Q-LOGIC 3 UPDATE 1.4.10 - RELEASE DETAILS

Affected Products:

All Q-logic 3 systems

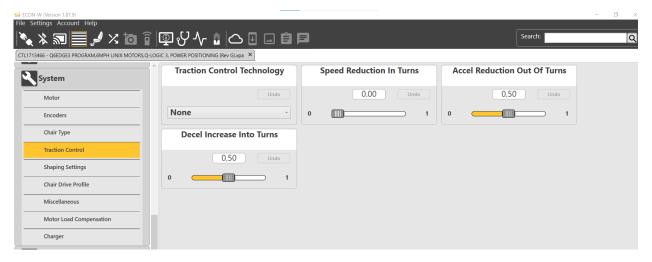
Frontwheel – Use this wheelchair type for 4Front and 4Front2 (coming soon). When the wheelchair type is set to frontwheel then the traction control setting can be set 2 ways (see next setting traction control technology for further explanation).

- 4Front frontwheel & Caster Sensors
- 4Front2 & 4Front2 HD frontwheel & STC (smart traction control)

Note: setting the 4Front to front wheel and STC will result in a speed reduction warning and reduced speed. Current 4front is not compatible with Smart Traction Control.
